**Presentation to Turitea Wind Farm Board of Inquiry  
Philip Dickinson 2010 March 23**

It was known to the Board of Inquiry that I did not agree with the revised New Zealand Standard NZS 6808:2010 Acoustics – Wind Farm Noise and I was asked to explain my reasons. It was intended that I talk to a Power Point presentation, but unfortunately the computer at the hearing would not handshake with the data projector and the presentation suffered as a result. This brief is to clarify some of the matters raised and to provide a précis of my concerns about the revised Standard and its application to wind farm noise in New Zealand.

Figure 1

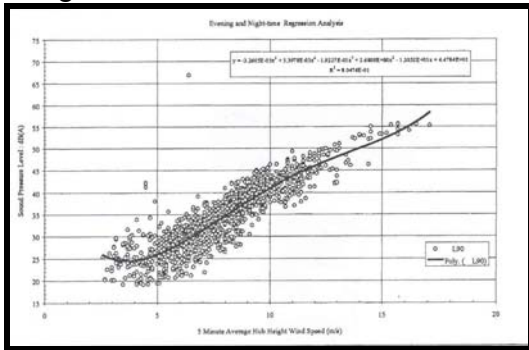
I will be referring to some of the figures and tables in my paper “Nonsense on Stilts”. These are shown on page 6 of this summary of the presentation. Figure 1 gives a graph of typical data pairs of wind speed at hub height and background level measured at a local residence, and shows a wide spread of data – often 20 dB but in one place 46 dB. Even though the data spread is so wide, it is considered acceptable to take a medium value as the relationship. Mathematically this is suspect, as one is comparing an L90 (mathematically a 10 percentile level) with a linear parameter from which a 50 percentile level is deduced. In other use of such data, it is usual to take one or two standard deviations down from the average as a more reasonable relationship.

Figure 2

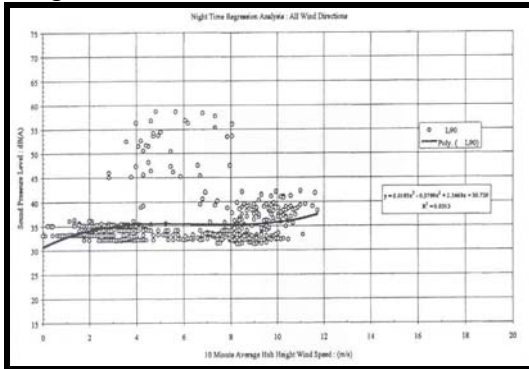
Figure 2 in the paper shows the data that can, and does, result from the use of instrumentation that does not have a sufficiently low noise floor (the internal noise of the instrument) to accurately measure the lower levels of sound. In this case, anything less than 28 dB is recorded as 31 or 32 dB. I have personally seen instrumentation with this limitation being used to measure wind farm sound. The background sound is being artificially raised to allow the wind turbines to make more noise. The Standard does not specify the instrumentation to be used, other than to say in clause 7.2.3 that “...in some cases a sound level meter with a low noise floor (such as a class 1 meter) may be necessary...” This suggests any class 1 sound level meter is satisfactory, but although most modern class 1 meters have a noise floor below 25 dB, few are below 20 and quite a number in common use may have a noise floor as high as 30 dB (as suggested in Figure 2). This artificially raises the value for the background sound even further. In some country areas of New Zealand the background sound level can be well below 20 dB.

Figure 5

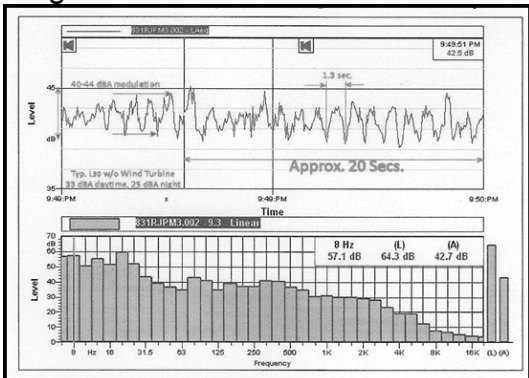
6 The revised Standard suggests C3.1.3 that there is little or no low frequency sound. Figure 5 in my paper shows a typical wind turbine noise spectrum recorded at about 800 metres from a turbine. Even at that distance, almost 95% of the sound energy is below 20 Hz (infrasonic) and almost 98% below 125 Hz (low frequency). These frequencies can, and do, excite room resonances in the typical New Zealand bedroom and produce severe annoyance and sleep disturbance. There should be a low frequency control limit set to protect sleep from this disturbance
